IMMEDIATE  
SERVICE  
NOTICE

NO. 179A

SUBJECT  
2236 MXD AT 19.2K BAUD. ECN'S

THIS ISN REPLACES ISN 179.

1. 210-7290-1 (ECN 9447)

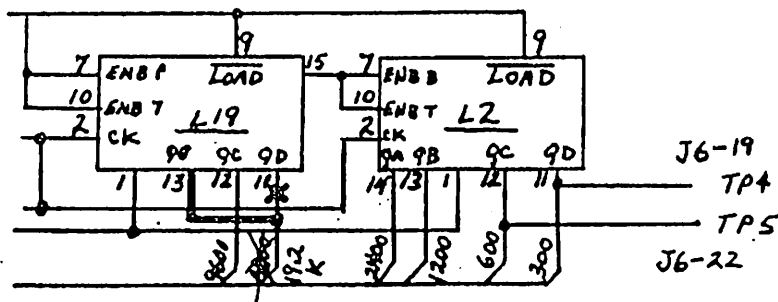
- A. Isolate L19 pin 11 from the etch that connects it to the baud rate switches.
- B. Tie L19 pin 13 to the etch that was connected to L19 pin 11.
- C. Change E-REV from 0 to 1.

2. 210-7292-1 (ECN 9210)

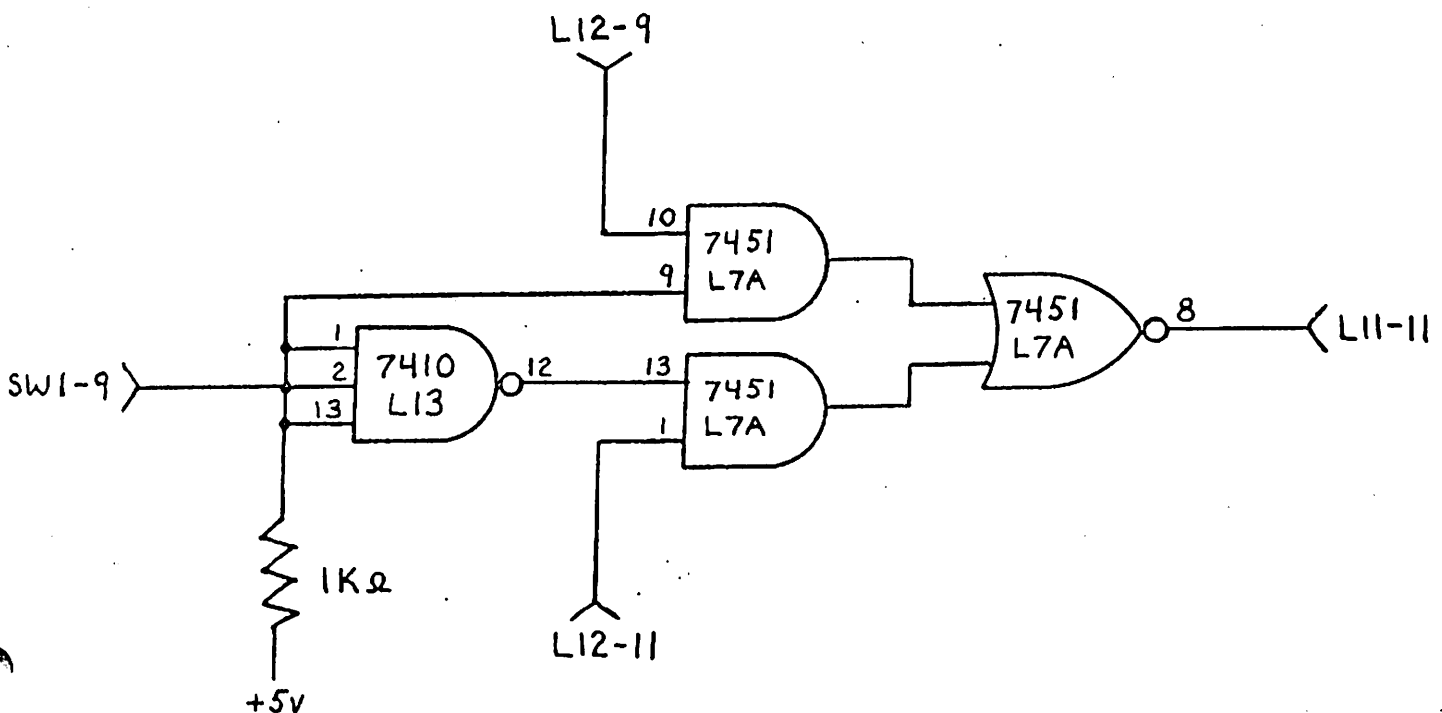
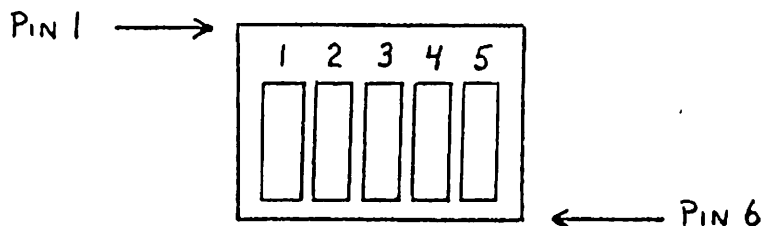
- A. Cut etch connecting L12 pin 9 to L11 pin 11.
- B. Add the circuitry shown below, using a 7451 I.C. (376-0012).
- C. Change E-REV from 3 to 4.

1. If location 7A is occupied by a 74175, return the board to the Home Office.
2. The square plate through designating pin 1 of SW 1 is actually pin 6.

- SW 1 pin labeling on old schematics is wrong.
3. If pin 9 of SW 1 is occupied by Parity Inhibit (PI), move the wire that is connected to SW 1 pin 9 to SW 1 pin 10. With Parity Inhibit tied to pin 10 of SW1, the board will conform to the new schematics.
  4. For 19.2K baud, the switch (SW1) must be set as follows:

ECN #8232, E-REV 2

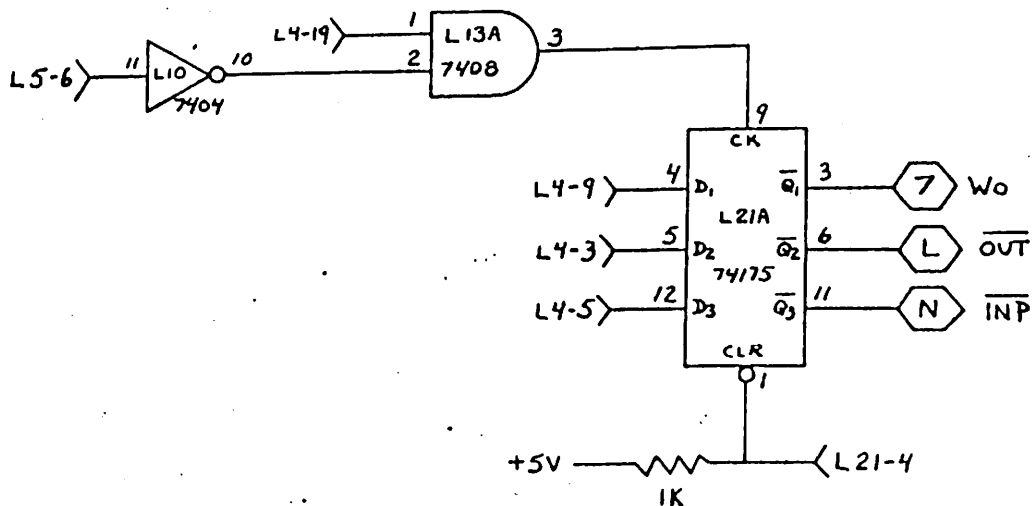
1. Insert a 74175 (WLI #376-0119) into location L21A. Pin 1 should be located toward the top of the board. Connect pin 8 to +0V and pin 16 to +5V.

2. JUMPER	From	To
	L5-6	L10-11
	L4-19	L13A-1
	L10-10	L13A-2
	L13A-3	L21A-9
	L21A-1	L21-4
	L21A-3	Conn. 7 <sub>4</sub>
	L21A-6	Conn. L <sub>4</sub>
	L21A-11	Conn. N <sub>4</sub>
	L4-9	L21A-4
	L4-3	L21A-5
	L4-5	L21A-12

3. Add a 1K resistor (330-3010) from L21A-1 to +5V.

4. Increment the E REV level from 1 to 2.

Figure A: Added Circuitry of ECN 9210 for the 210-7292-1

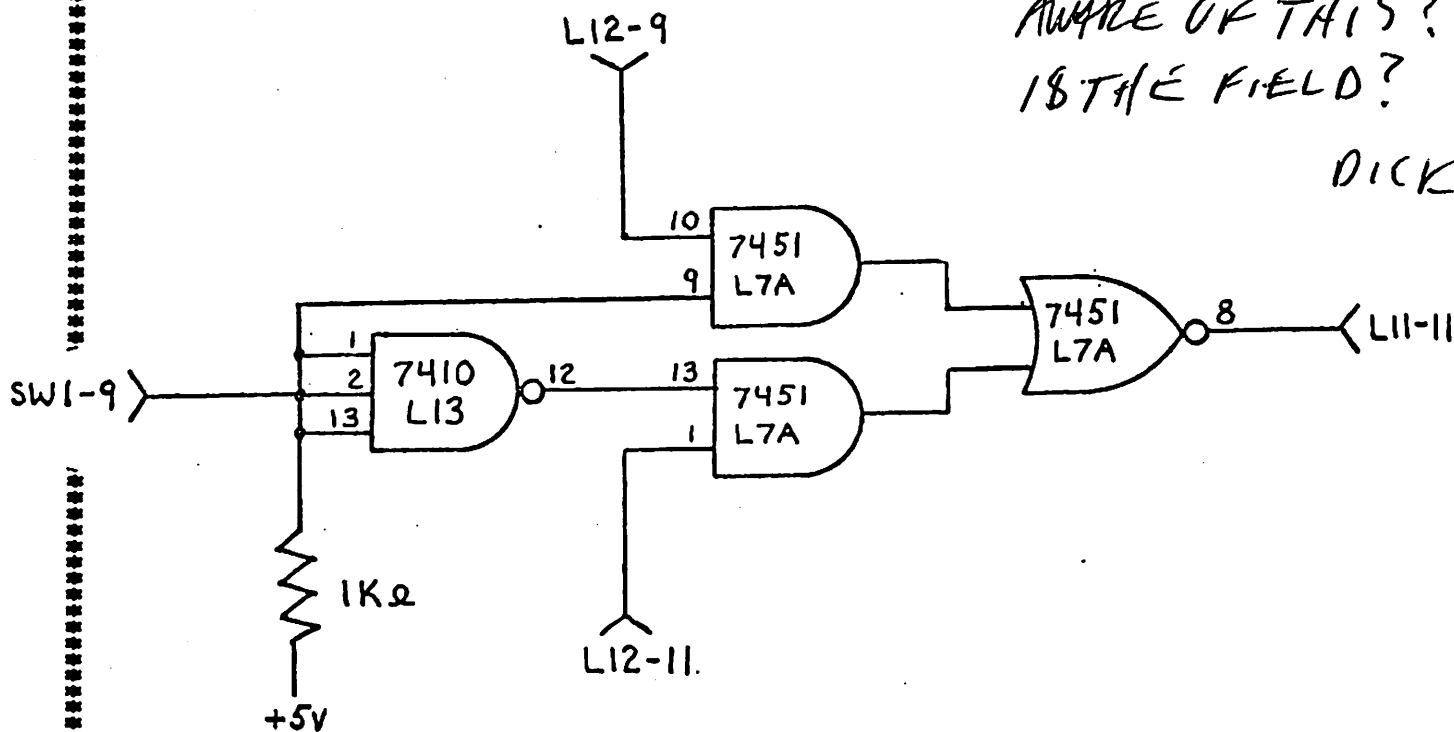
Recently it has been determined that a few 210-7292-1 PCB's presently released to the field from the Home Office have been updated incorrectly. Referring to ISN #179A - Section 1 and Figure A below, the error involves ECN #9210 and is as follows:

The wire connected from L12 pin 9 may be found connected to L7A pin 1. This wire should be connected to L7A pin 10.

Similarly, the wire connected from L12 pin 11 may be connected to L7A pin 10. This wire should be connected to L7A pin 1.

As per ISN #179A and Figure A below, the following remains valid:

- L12 pin 9 is connected to L7A pin 10
- L12 pin 11 is connected to L7A pin 1
